City of Greater Geelong
WADAWURRUNG COUNTRY
PO BOX 104 GEELONG VIC 3220 AUSTRALIA

Date: Friday 29 September 2023

Scope of this Statement and associated Report

This report forms a review of the Jetty Road Urban Growth Plan (JRUGP) and associated drainage matters. Specifically:

Figure 3. Endorsed Development Plan (iii) Catchment and SWMP

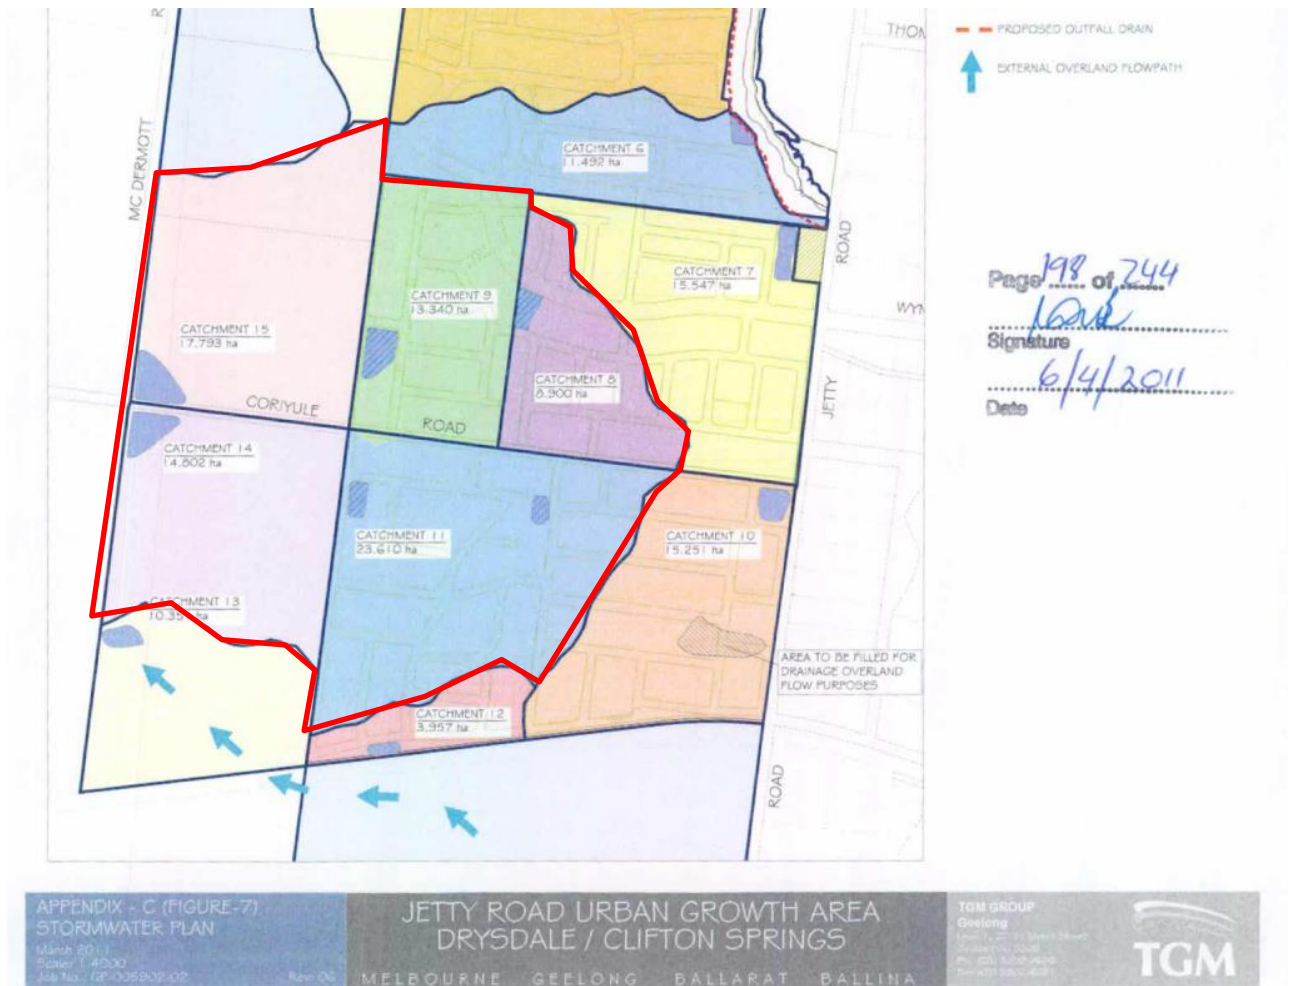
the JRUGP were considered in the SWMP. The catchment plan contained in this document can be seen in Figure 3, with the catchments of interest highlighted.

The TGM SWMP does not provide any calculations as to the expected flows from the catchments (pre or post development) but does quote that the following was used in the formulation of basin requirements:

- Noted they used an Adam's method formulation for pre-development flows Time of Concentration calculation.
- Noted that they used a Runoff Coefficient of 0.33 for the pre-development Q_{100} flows.

- Have not stated what other timing assumptions are used for post-development flows (TC method, slope assumptions, Runoff Coefficients)
- Have only stated the 100y ARI calculations, it is unclear if the 5y and 1.5y ARIs were considered as per the JRUGP objective.

- The report does state that the 3 month, 5y and 100y flows should be matched for discharges to Griggs Creek but does not show how this is achieved or if this is applied to other outfalls.

- There is a suggestion that the wetlands will attenuate the 3 months storm, and that if the 100y storm volume is calculated the more frequent storms can also be attenuated in this volume. No calculations have been provided to show this, though this is logically possible.

- The report suggests that the basin locations as shown are conceptual in nature only and may be subject to future consolidation by negotiation between landholders.

- Wetland sizing has been completed in MUSIC, though the assumptions for each of these treatment systems is unclear. It is suggested that EDD is between 350 and 400mm.

- McDermotts road draining catchments have been assumed to have a shallower possible outfall depth of 1m.

To check the basic sizing within the SWMP against industry ratios the stated areas have been reverse engineered from the reported assumptions, and the listed volumes in the report and are shown in 0. Generally, across Victoria an expected volume to hectares ratio for residential development should be anywhere between 300-600 m^3/ha dependent on rainfall band and development intensity. The nominated density in the JRUGP is 14 lots/ha minimum. These rates without any further information or detail would seem on the low side of contemporary understandings.

Contemporary water quality sizing for a wetland system is around 3-4% depending on rainfall banding, EDD selection and catchment density. Again, the shown rates would seem on the low side, but given the calculation age (2011) these rates may have been possible (newer standards are more prescriptive and as such require more land).

Figure 7. Undulations in Coriyule Road pipe alignment (COGG, 2015)

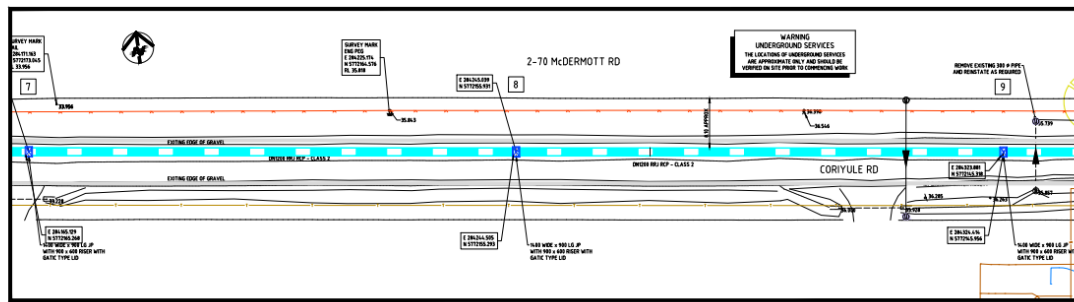
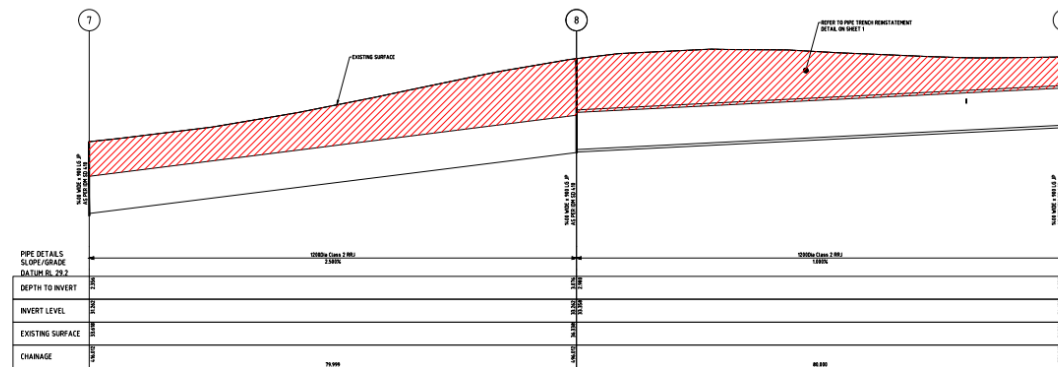
Based on these descriptions, the stated JRUGP objectives, terrain analysis, and resulting pipe alignments it would be hard to argue that a piped solution to the outfall would not be required for Stage 1 works from these catchments.

Figure 8. Stage 2 Western Outfalls

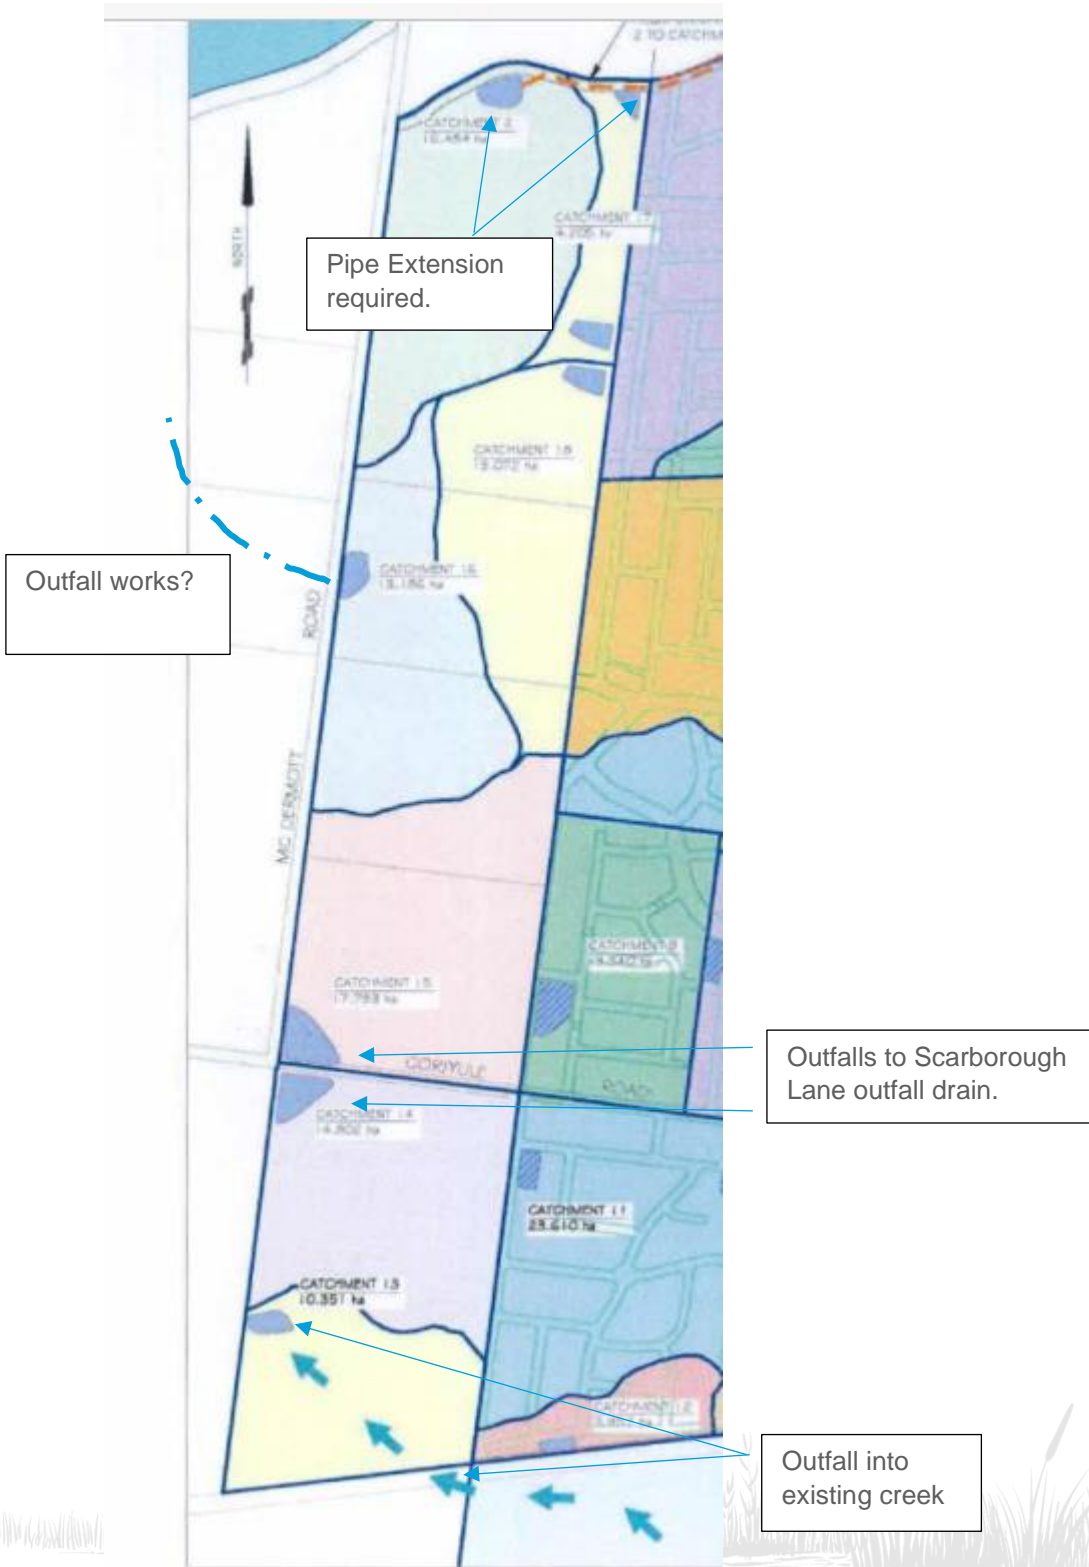
As highlighted in the TGM (2011) report at least 4 outfalls are required for the Western Areas. These are highlighted in Figure 8, but can be cross referenced somewhat with Figure 6 above. Consideration of these outfall requirements should be made in conjunction with the Stage 2 DCP works. Specifically:

- Northern outfall - an extension of the outfall drain provided for property 1 as shown in the SWMP is required to drain properties 11 and 12 and parts of property 13. Given that this piece of infrastructure benefits multiple properties it would generally be considered a DCP item unless developer agreement can be sought. Similarly, the outfall wetlands for these properties could be combined for better efficiency.

- Midpoint outfall - The currently proposed midpoint outfall is to a local low point on McDermott Rd. There is not however a discernible flow path past the existing dam on McDermott Rd, and as such any change in volume or frequency will be experienced acutely. As such, without further outfall works (pipe or easement to waterway) there is likely to be concerns with this approach. An alternative is to pipe (as a minimum low flow) to the northern outfall with storages to limit the flow

rate to the defined pipe capacity. This approach would further the argument for the northern outfall extension (properties 11,12,13 connection) to become a DCP item. This issue is highlighted in Figure 8 and Figure 9. These points are also considered in the WT, June 2022 document.

Figure 12. Proposed Southern Catchment SWMP

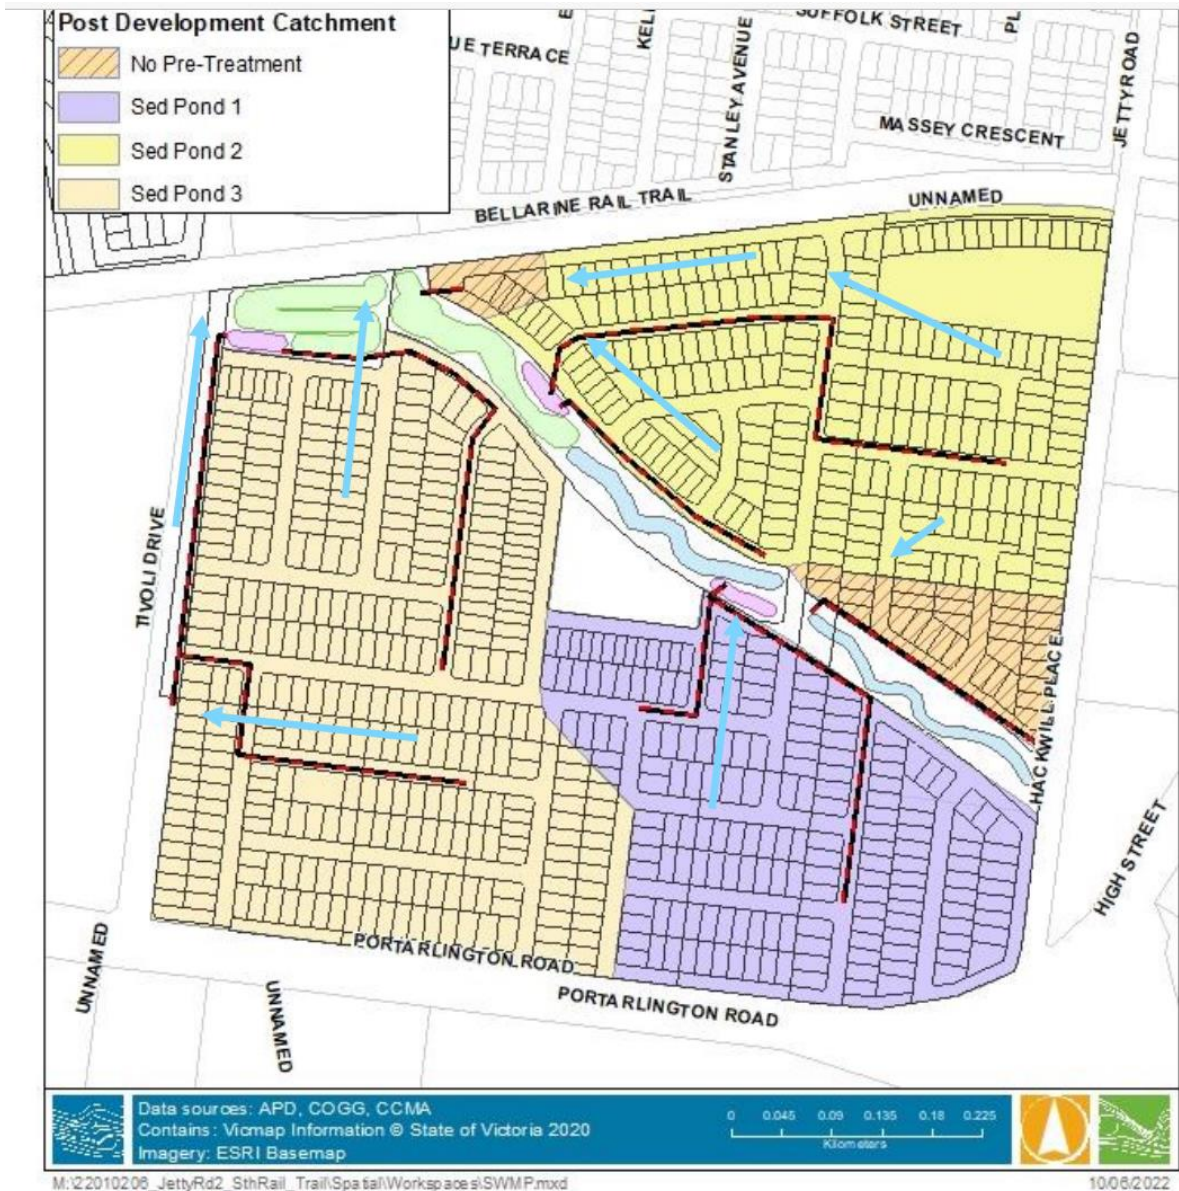
The southern areas have proposed a constructed waterway and basin system to meet the objectives of the JRUGP. The basin system has been calibrated to meet the 100y, 10y and 1.5y ARI's (missing the 5y JRUGP objective) however this is not considered a consequential change (Figure 13). Given that this waterway and basin serves a number of properties (16-30) this area would also be a possible DCP area if landholder agreement cannot be reached.

Figure 15. Jetty Road Infrastructure Plan

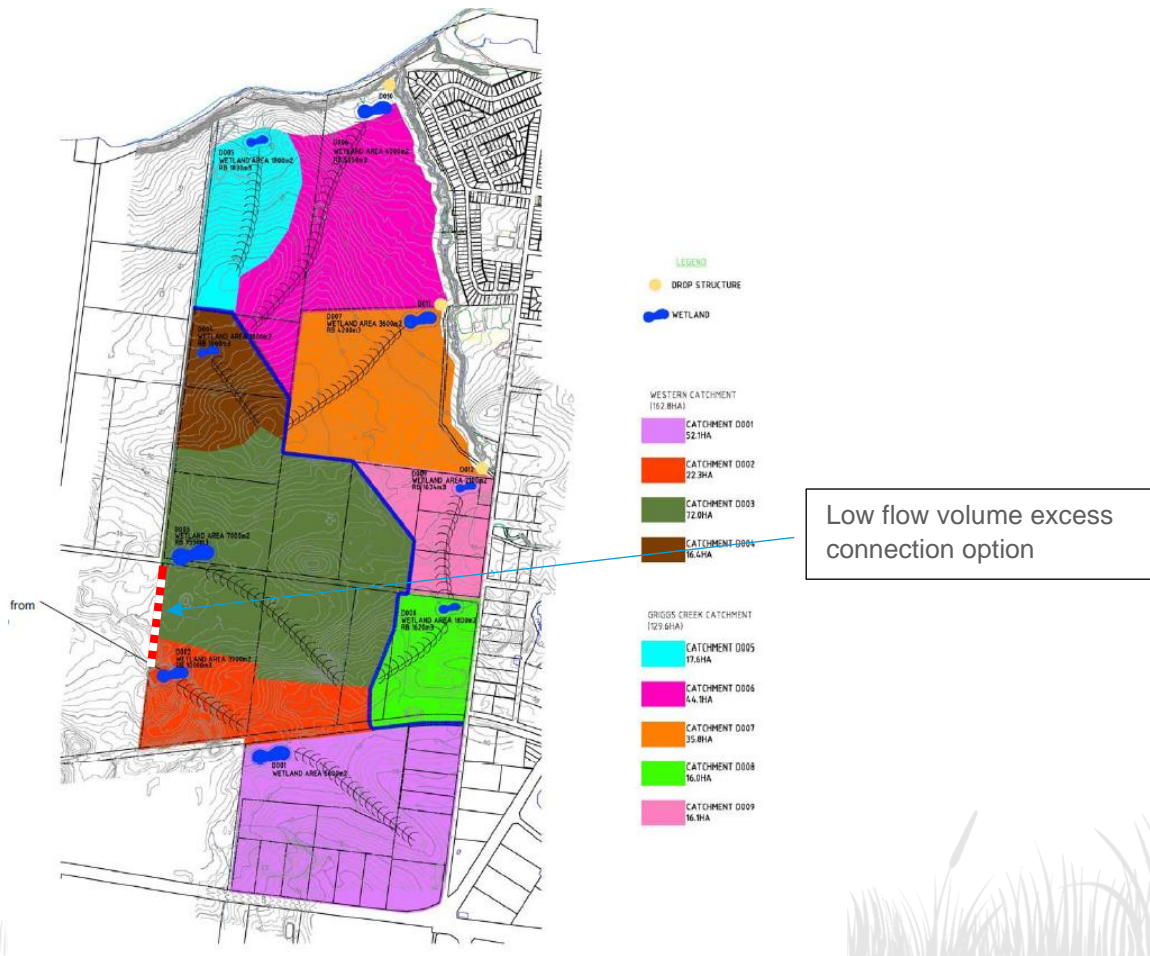
In all likelihood if the outfall strategy was identified earlier, then it would have been added to the DCP, with apportionment including part of the Stage 2 works. The apportionment of these pipe works **at the time** would have been closer to the dark green area as shown in Figure 15 and contained in the Jetty Road Infrastructure Plan. This is an area of approximately 71ha, of which approximately 40ha is contained within the Stage 1 area (in subsequent works approximately 8-10ha of the orange areas has been added to this catchment to align with the TGM SWMP). The works also provide drainage improvements for Coriyule Road itself and as such a proportion of the works could be Council funded.

Whilst these options and values have not been cross checked; they are in the general order of magnitude of options I have tested in similar projects. As such it would seem that the Ocean Outfall connection is the most viable of these options. To meet the performance objective a low flow pipe for the area would be required, with the most efficient location on property 15 as shown in Figure 15.

Given the number of properties addressed by this pipe it is suggested that this would be a Stage 2 DCP item. This in turn would require all of the properties 15 through 30 to contribute to the Scarborough Road outfall drain as constructed in Stage 1 (Orange and Magenta areas as shown).
